Detailed Site Plan Departure from Sign Design Standards Wawa Old Branch Avenue

DSP-19056
DSDS-710

SUBJECT: Detailed Site Plan DSP-19056
Type 2 Tree Conservation Plan TCP2-041-2020
Departure from Sign Design Standards DSDS-710
Wawa Old Branch Avenue

SITE PLAN

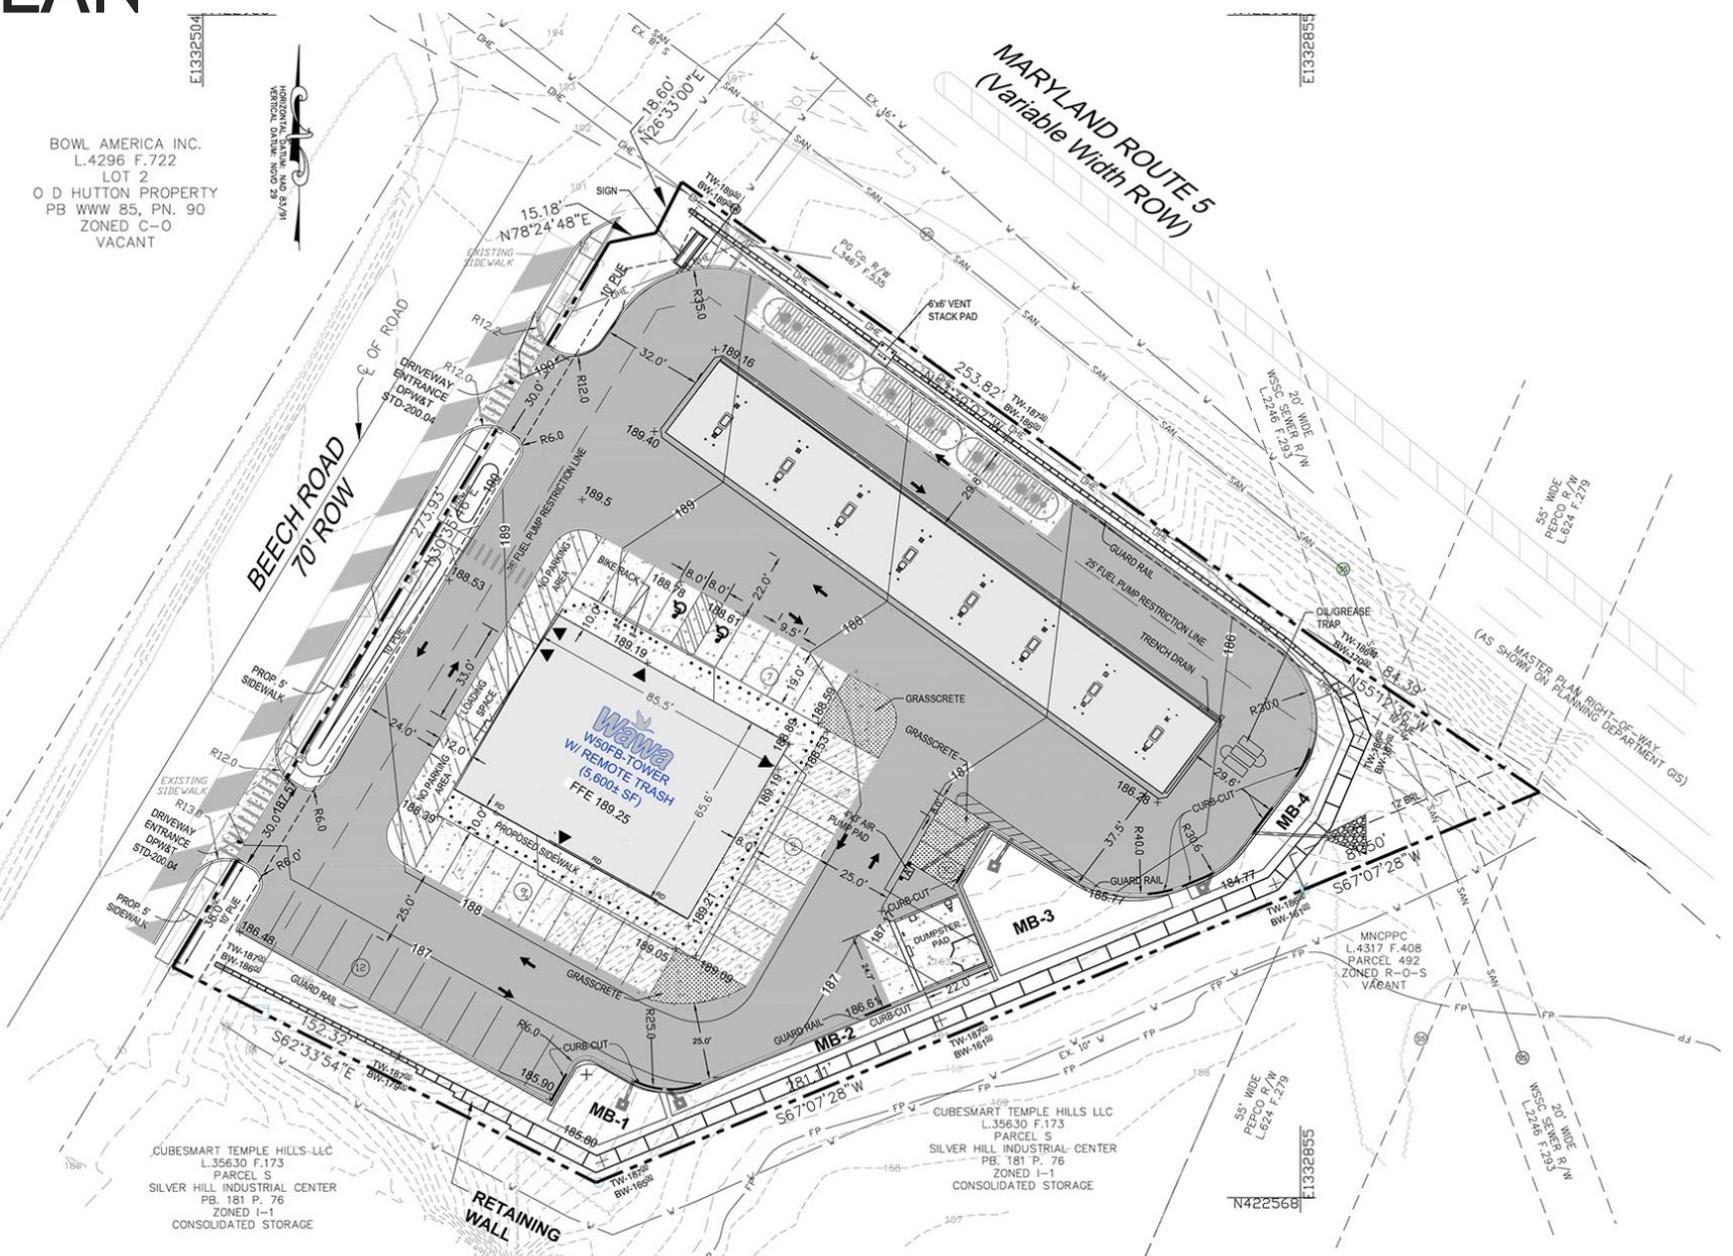
this still shows the wall at the front of the property. it doesn't affect the truck turning, but reviewer may comment.

does this need to be included in plan set?

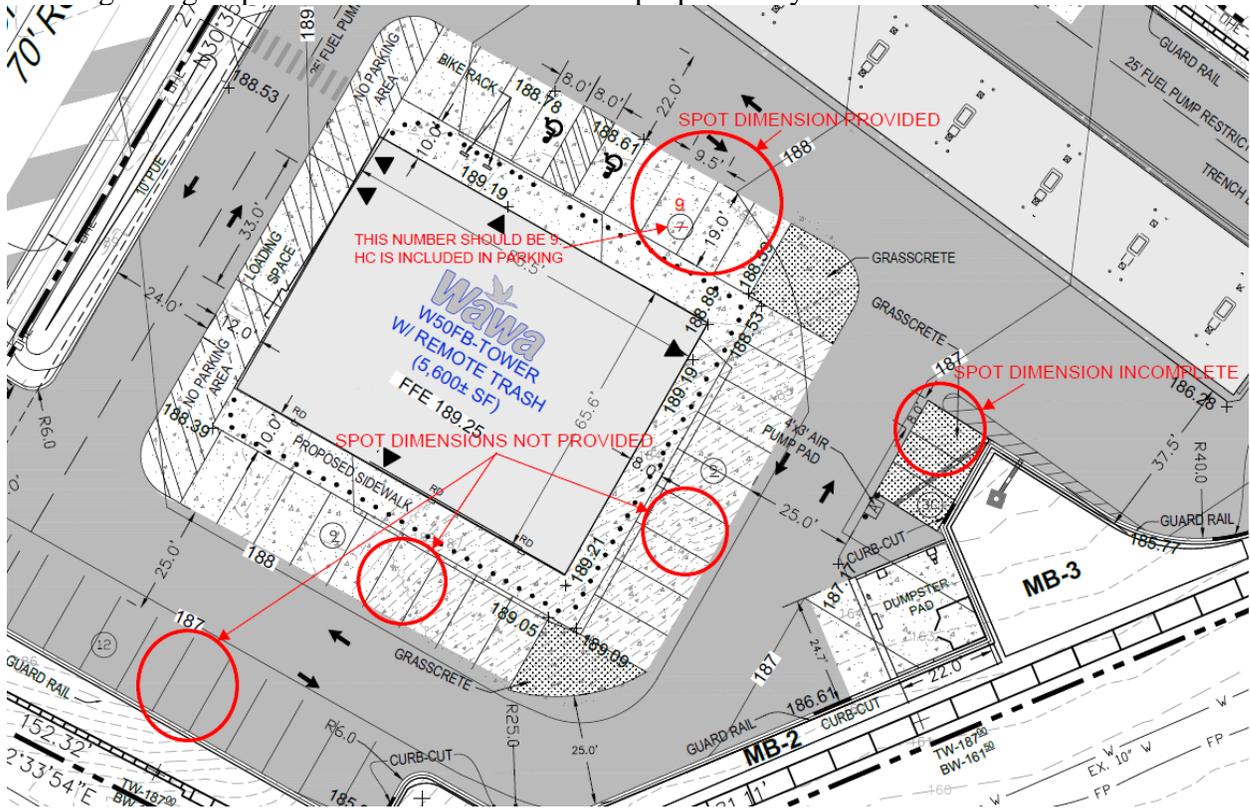
- Plans do not meet all the requirements of Sec. 27-253(c) of the Zoning Ordinance. For example, the proposed use and height are not shown on the convenience store or canopy. No dimensions are provided for the canopy. These are first blush comments. Applicant must go through Sec. 27-254 © and ensure their plans meet the requirements listed.

- Provided number of parking spaces is off and applicant has not included the employee parking requirement in their parking table. Parking table is also not well laid out to clearly demonstrate what they are parking for, what the requirements are per Part 11, what the formulas for calculating the parking is and what the resultant numbers are – Required and Provided. I would recommend a parking table similar to what is shown below (I have used two employees for the convenience store in this example). Please remember that HC spaces are not a separate count. They are to be included in the total parking spaces provided:

- Each parking bay should show one spot dimension (both length and width). Applicant is only showing a single spot dimension for one of the 5 proposed bays:

- Show building setback front street line and freestanding sign setback from street line to demonstrate conformance with Sec. 27-614(a)(1) and (a)(4).
- Applicant provided a comprehensive sign table centrally located, which is great, but its formatting makes it hard to follow and understand how the totals and percentages add up to demonstrate conformance to Part 12 of the Zoning Ordinance. It also does not clearly communicate the 50% channel letter reduction or that the DSDS is necessary for the sign height and 20.11 SF sign area coverage. I have no specific recommendation other than to please revised the sign table to be easier to follow and understand for the permit reviewer at the time of sign permit application.
- It is important to note that any revisions made to the site plan based off these comments must be mirrored on the landscape plan (as applicable).
